AMENDMENT NO. 0003 TO RFP W912DR-04-R-0054  
EFFECTIVE AUG 06, 2004

<b>PROJECT: RENOVATIONS TO CONMY HALL                  BUILDING 241, FORT MYER                  ARLINGTON, VA                  AMENDMENT No. 3</b>	DATE:	08-06-04	<b>DRAWING #  M2.1-1</b>
	SCALE:	AS NOTED	
	JOB NO.	020201	
	REFERENCE DWG .NO.	M2.1

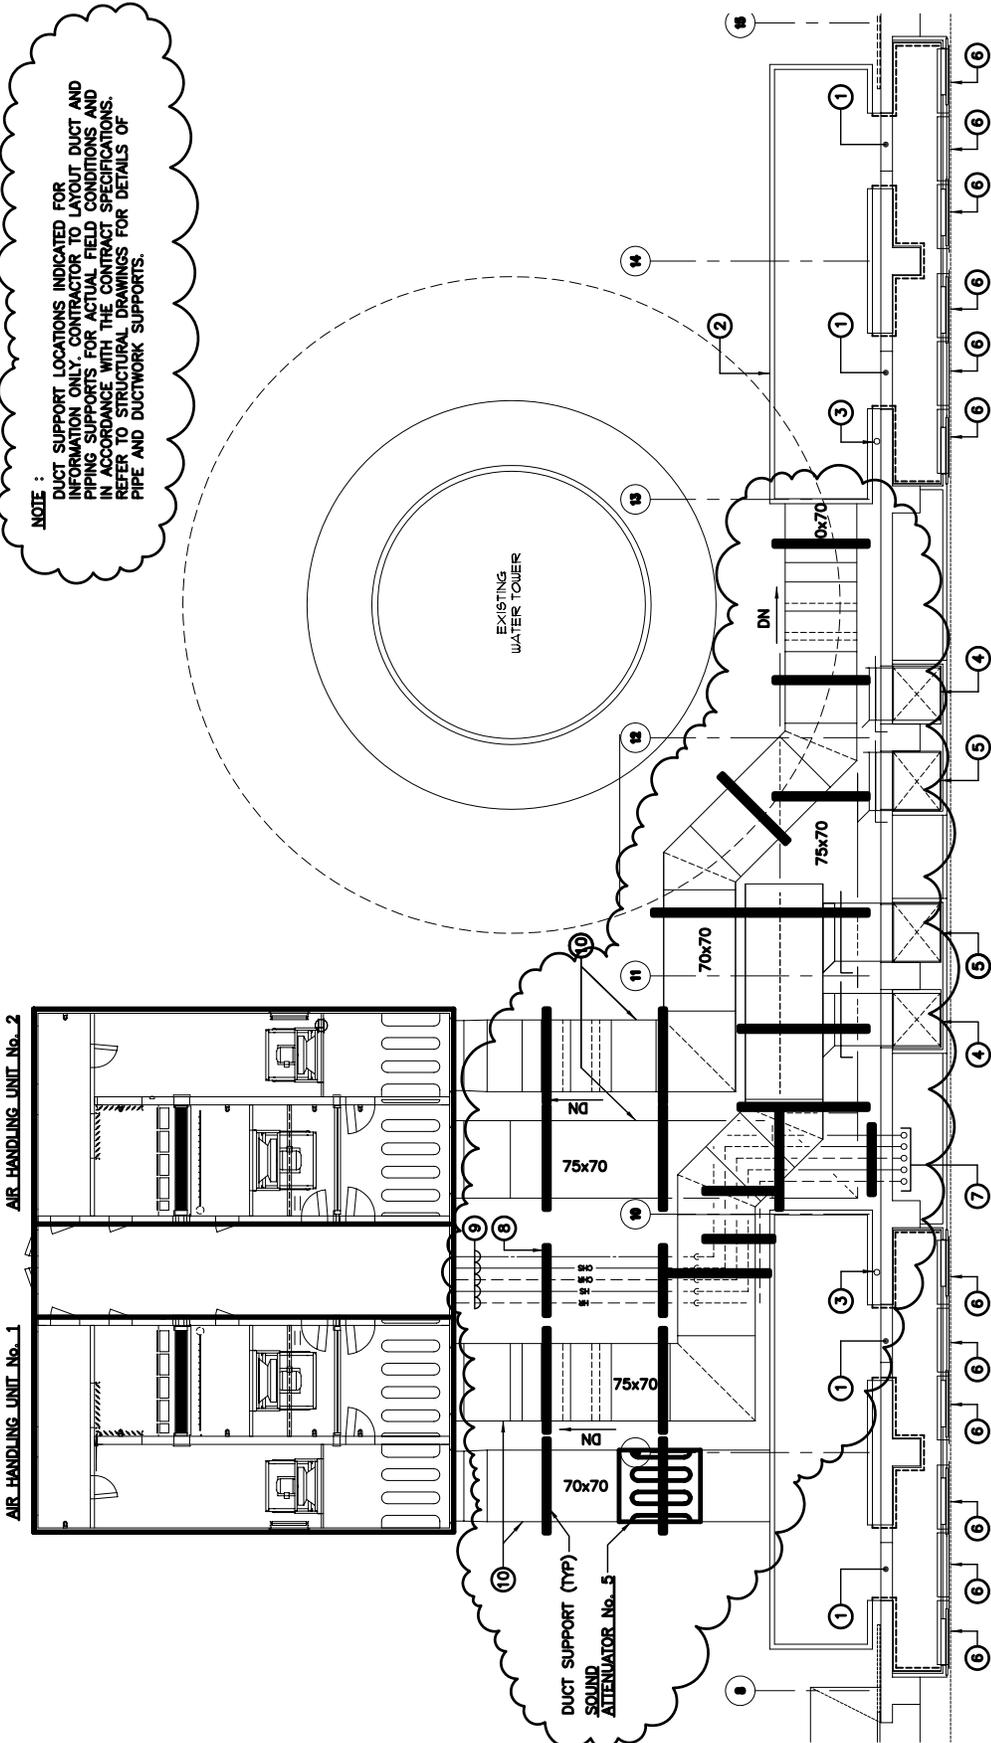
- 7) Sheet M2.1: Revise as indicated on attached Sketch M2.1-1, dated 8-6-04.
- 8) Sheet M3.2: Revise as shown on attached Sketches M3.2-3 and M3.2-4, dated 8-6-04.

- ① EXHAUST DUCT SHALL BE TIGHT TO CEILING, SLOPE DUCTWORK WITH CEILING.
- ② 1" CONDENSATE DRAIN, DISCHARGE AT GRADE. PROVIDE CONCRETE SPLASH BLOCK
- ③ 52x46 SA UP, FOR CONT. REFER TO DWG. M2.3
- ④ 58x46 SA UP, FOR CONT. REFER TO DWG. M2.3
- ⑤ 72x72 CLEAR OPENING
- ⑥ 8'-0" HIGH x 8'-0" WIDE x 18'-6" LONG RETURN AIR PLENUM. DIMENSIONS ARE INSIDE CLEAR MINIMUM.
- ⑦ EXISTING 4" DIAMETER RAIN LEADER
- ⑧ EGG CRATE RETURN AIR GRILLES, REFER TO ARCHITECTURAL DRAWINGS FOR INSTALLATION DETAILS AND ADDITIONAL REQUIREMENTS.
- ⑨ 6" CHS, 6" CHR, 4" HS, 4" HR & 1" CW UP IN CHASE, FOR CONTINUATION REFER TO DRAWING M2.3
- ⑩ 8" CHS, 8" CHR, 4" HS, & 4" HR UP IN CHASE, FOR CONTINUATION REFER TO DRAWING M2.3**
- ⑪ 1" CW, FOR CONTINUATION REFER TO DWG. P2.2
- ⑫ 1" CW UP IN CHASE, FOR CONTINUATION REFER TO DWG. M2.3

<b>PROJECT: RENOVATIONS TO CONMY HALL          BUILDING 241, FORT MYER          ARLINGTON, VA          AMENDMENT No. 3</b>	DATE:	08-06-04	<b>DRAWING #</b>  <b>M9.1-4</b>
	SCALE:	AS NOTED	
	JOB NO.	020201	
	REFERENCE DWG .NO.	M9.1

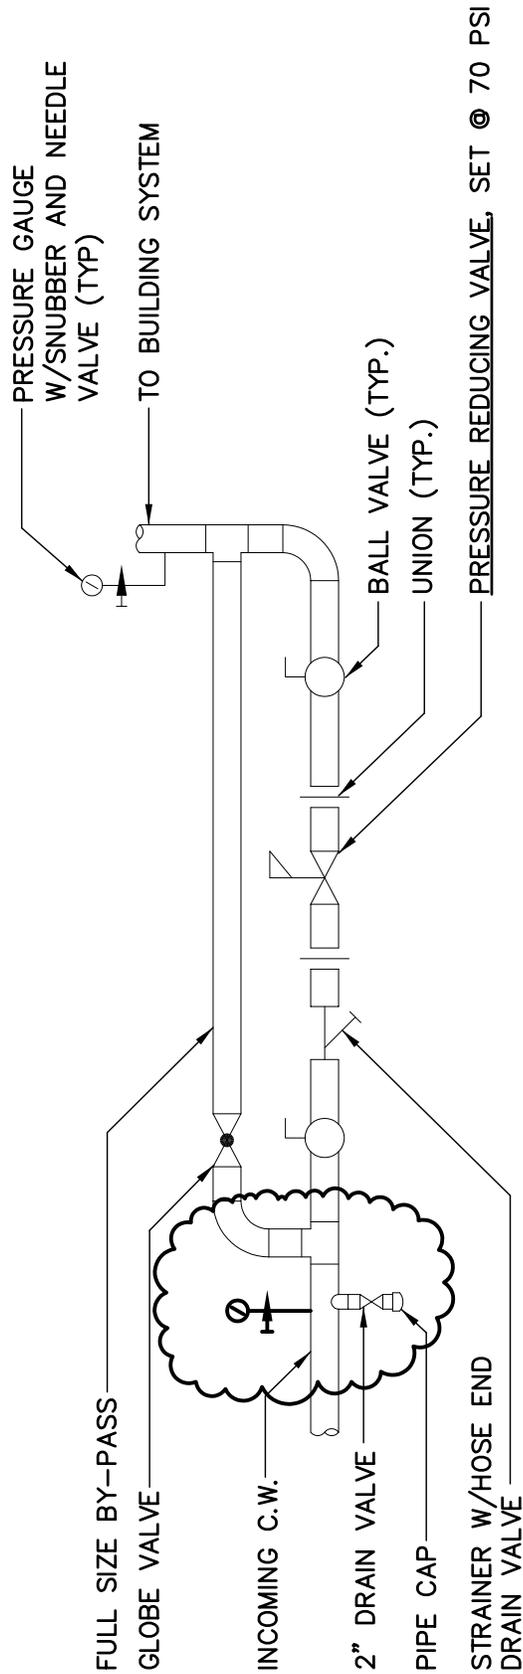
- 9) Sheet M9.1: Revise as shown on attached Sketches M9.1-2, M9.1-3, and M9.1-4, dated 8-6-04.
- 10) Sheet P7.1: Revise as indicated in sketch P7.1-1 dated 8-6-04.

DRAWING #  
**E4.4A**

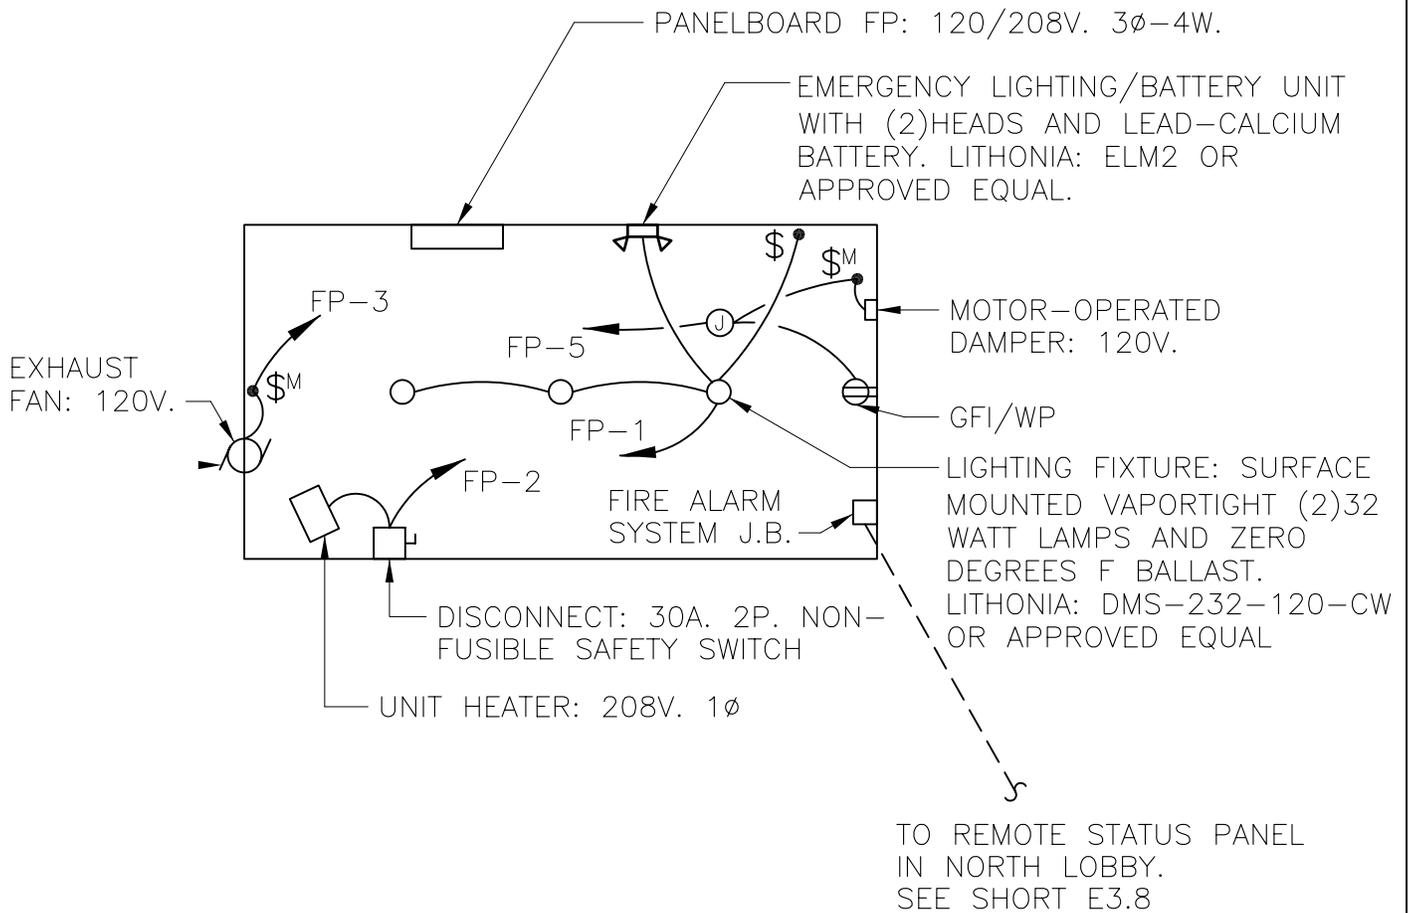
- 11) Sheet E4.4 (disregard amendment number on sketches for this sheet):
  - a) Part Plan – Fire Pump Enclosure: Replace as shown on attached Sketches E4.4A and E4.4B, dated 7-30-04.

PROJECT: <b>RENOVATIONS TO CONMY HALL BUILDING 241, FORT MYER ARLINGTON, VA AMENDMENT No.1</b>	DATE: 07-30-04	DRAWING #  <b>E4.4C</b>
	SCALE: AS NOTED	
	JOB NO. 020201	
	REFERENCE DWG .NO. E4.4

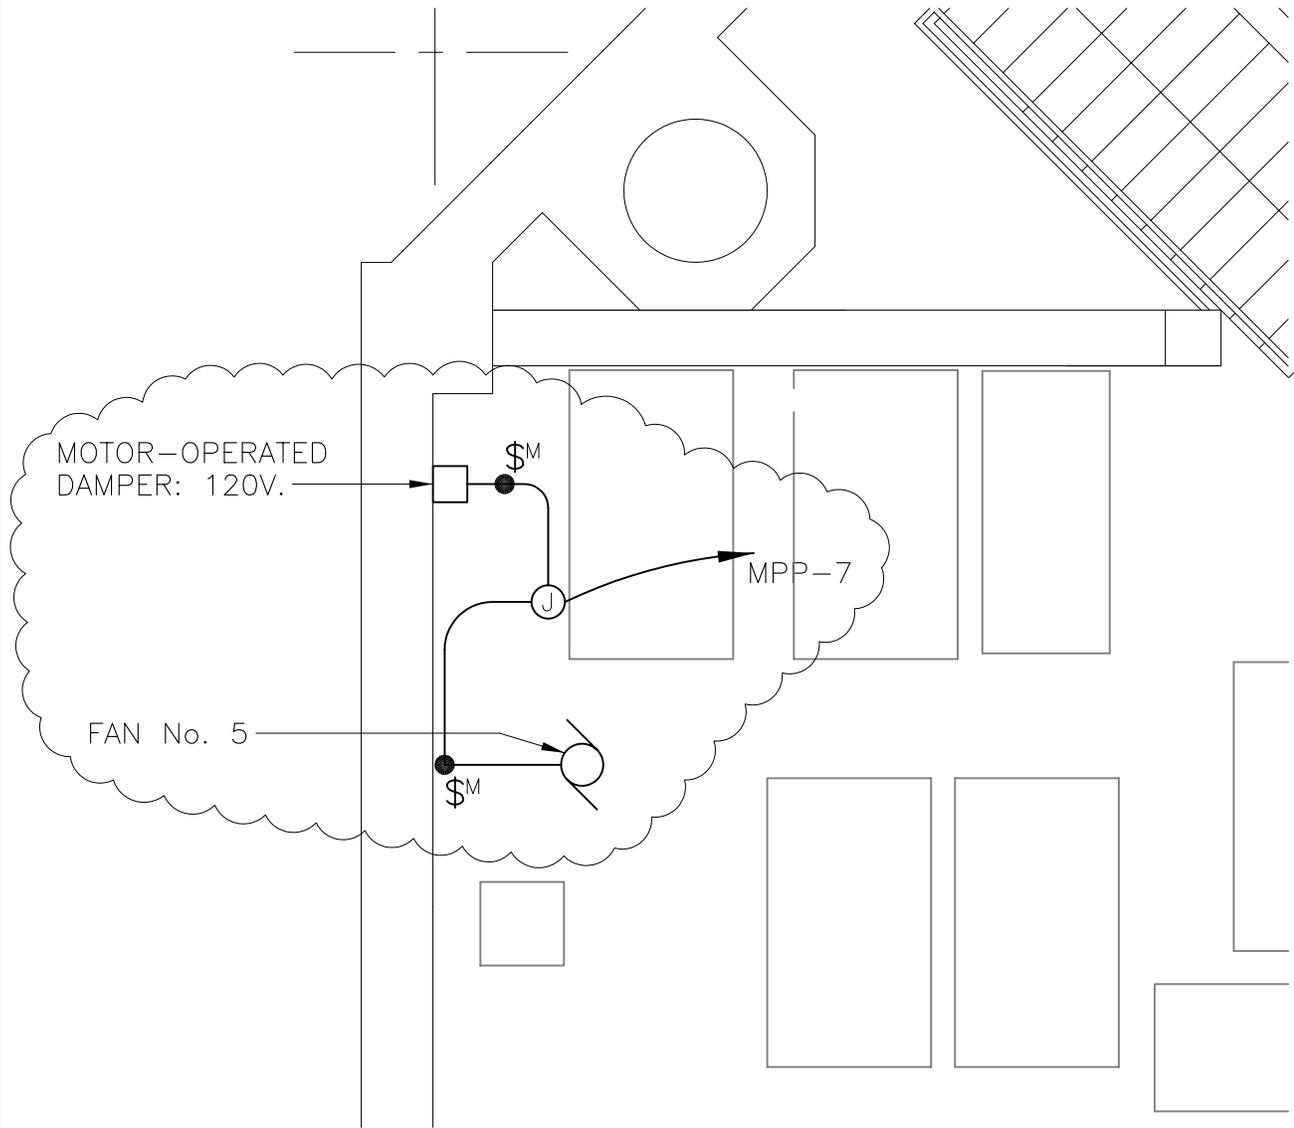
- b) Add detail per attached Sketch E4.4C, dated 7-30-04.
  - c) Partial Part Plan Mechanical Room: Revise per attached Sketch E4.4D, dated 7-30-04.

- NOTES: 1. PROVIDE MASS NOTIFICATION SPEAKER WITH LABEL ADJACENT TO EACH FIRE ALARM SYSTEM VOICE EVACUATION SPEAKER.
2. PROVIDE MASS NOTIFICATION STROBE WITH LABEL ADJACENT TO EACH FIRE ALARM SYSTEM STROBE.
